DRAFT Response to Comments on the Savannah Harbor Hydrodynamic and Salinity Model Acceptance Package: Part IV

Computational Hydraulics and Transport, LLC (CHT) for US Army Engineer and Research Development Center (ERDC) Comments (Billy H. Johnson)

Figure 3-7. Simulated salinity at GPA-06 for marsh runs

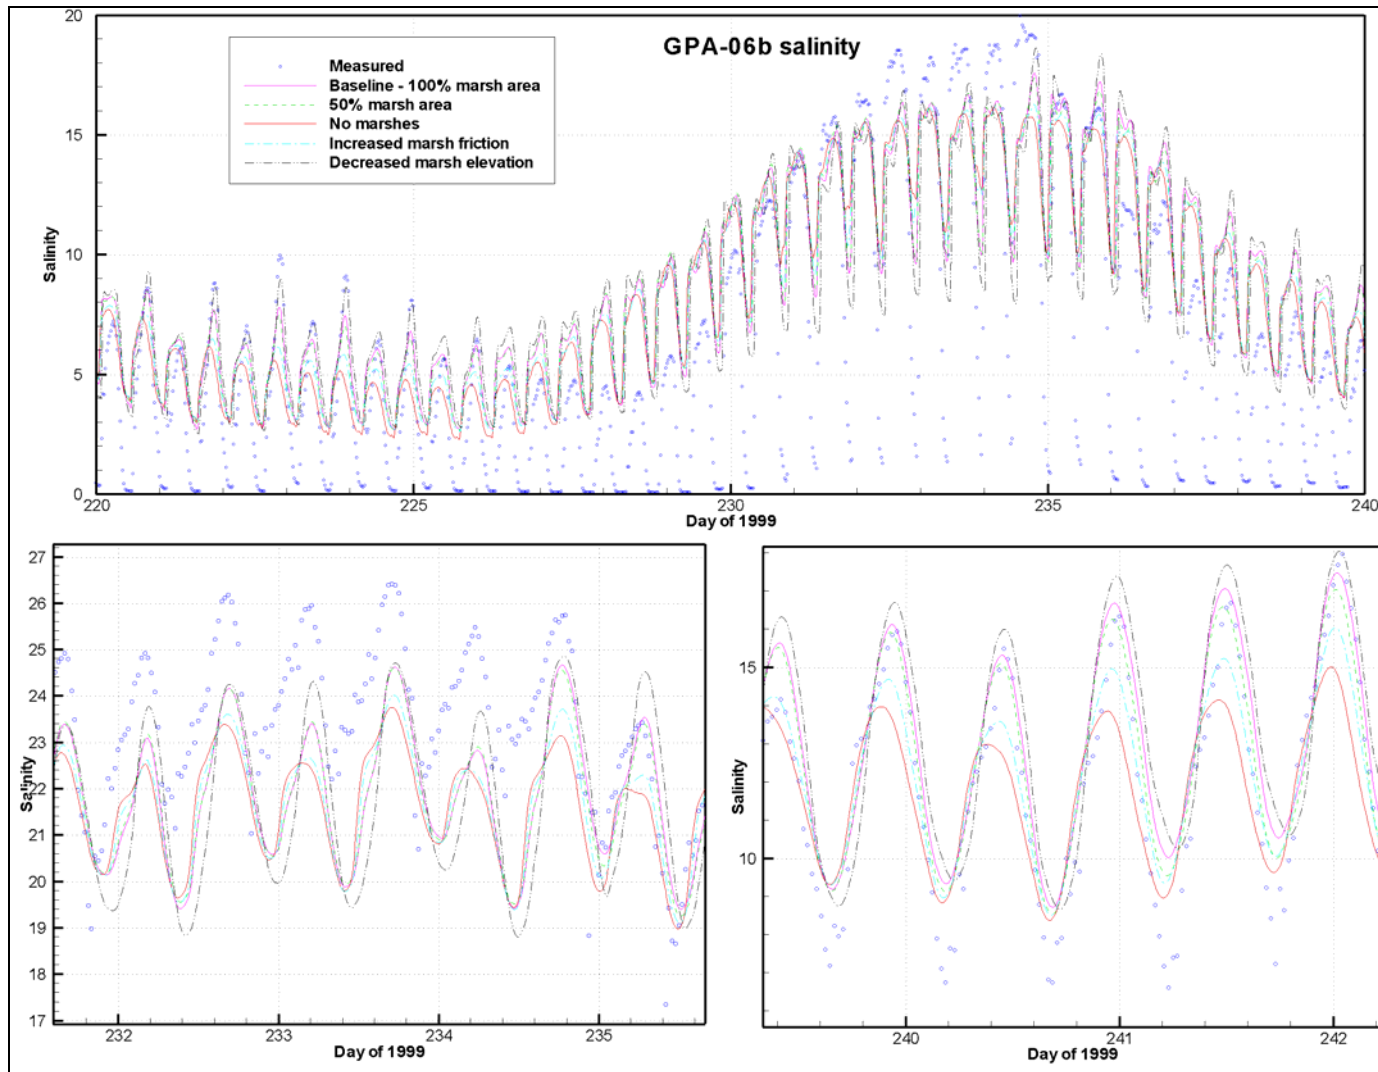
The commenter notes that the peaks of the simulated water surface elevations are flatter than the measured data, which may be caused by excessive marsh storage areas. The commenter also recommended varying the marsh storage area (and other marsh characteristics) to improve the tidal wave characteristics.

The simulation results for salinity at GPA-06 are shown in Figure 3-7. It can be seen that none of the variations from the baseline marsh configuration resulted in significant overall improvement to the salinity predictions.
